## Forest Stewardship Plan 780 – Esk’etemc Forest Development Unit FSP Major Amendment Number 10 - Change Summary and Rationale

**FSP Section 5.16-2 – Grassland Habitats (FDU 2):**

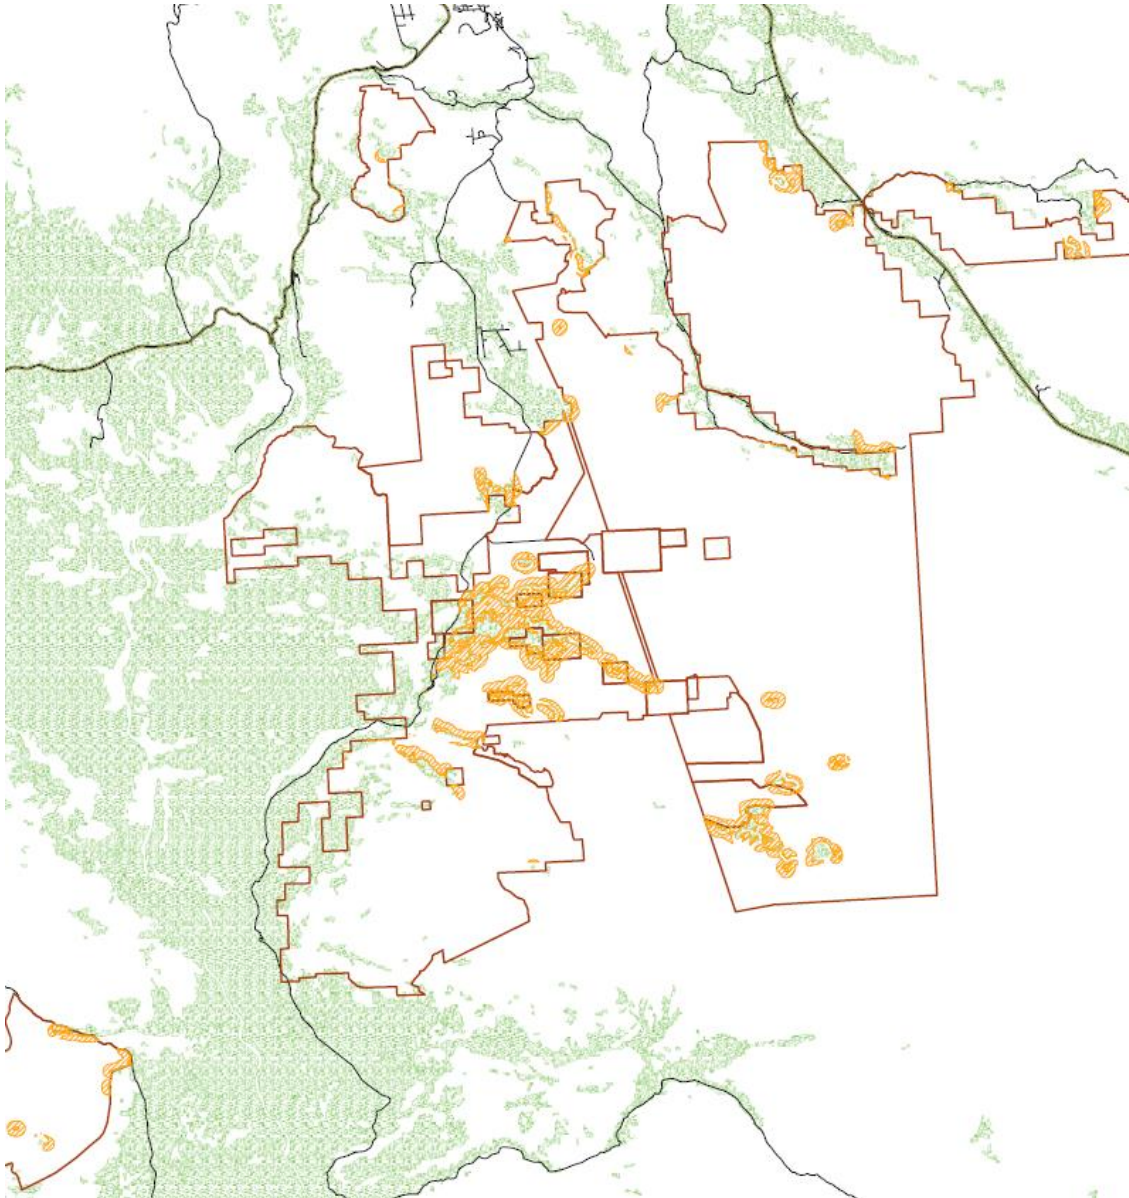
- Have modified clause 1 so that only sub-clause a is applicable. Sub-clauses b and c have been removed and incorporated into a new clause 2.
- Have inserted clause 2 and included sub-clauses a. and b. (previously b. and c. under clause 1) which apply to *Grassland Habitat* and *Grassland Habitat Transition Zone* as defined in the FSP R/S.

- Have updated reference for clause 4 (was previously clause 3). No other material changes to this clause or the associated sub-clauses made.
- Have inserted clause 5, which is a new clause that specifies the intended results at conclusion of harvesting for the *grassland habitat transition zone*.

A key component of this amended result/strategy is the area used to define the grassland habitat transition zone. A 300m buffer is being put forward and will exclude areas that overlap with Ungulate Winter Range, all Old Growth Management Area's, all Lakeshore Management Zones as well as *No Harvest Areas* as defined in this FSP. In total once the buffer is applied and excluded areas are removed there is a maximum of 4,001.9ha of area within FDU 2 to which the *Grassland Habitat Transition Zone* may apply. The following image shows the areas that are included in the grassland habitat transition zone (Orange crosshatch):

Clause 5 identifies key management outcomes within the transition zone. Specifically, upon conclusion of harvesting there is a requirement to retain a minimum of 10m<sup>2</sup>/ha of total stand basal area, retain all stems > 65cm dbh, and retain all deciduous stems > 12.5cm dbh where practicable. A minimum post-harvest basal area target of 10m<sup>2</sup>/ha is being put forward to facilitate establishment and maintenance of an open forest condition adjacent to grasslands. The post-harvest basal area target of 10m<sup>2</sup>/ha will support a transition from the Grassland Benchmark Areas of around 2m<sup>2</sup>/ha to full forest at 18 to 20m<sup>2</sup>/ha.
